# **Blackheath Station Upgrade**

## Determination Report

# **Blackheath Station Upgrade – Determination Report**

**Figure 1.3 Key features of the Proposed Activity**

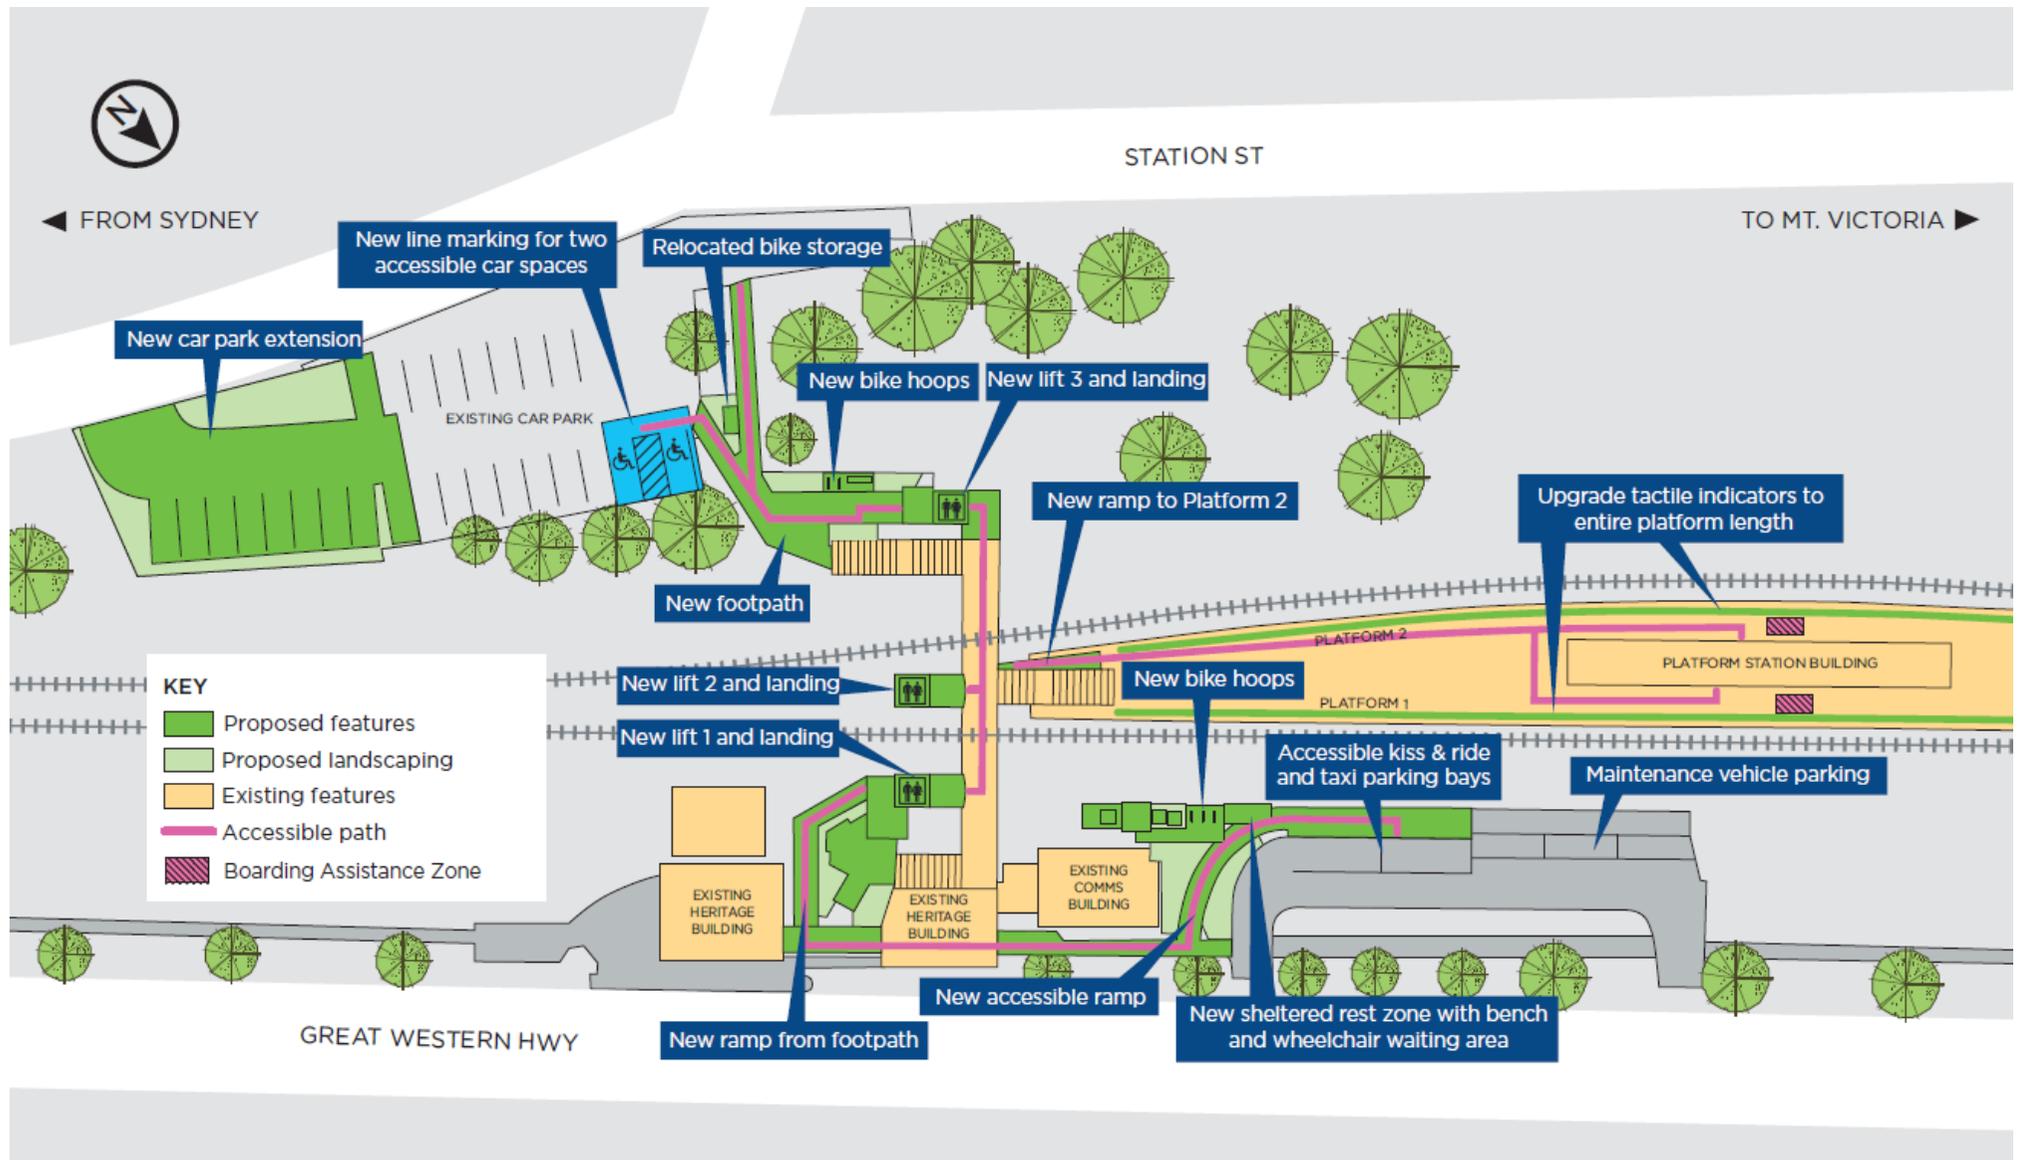
Issue no.	Issue/s raised	TfNSW response
<b>1</b>	<b>General</b>	
1.1	Council requested that lift numbers are added to the lift labelling on the Key Features figure.	Lift numbers have been added to the Key Features figure in this report (see Figure 1.3).
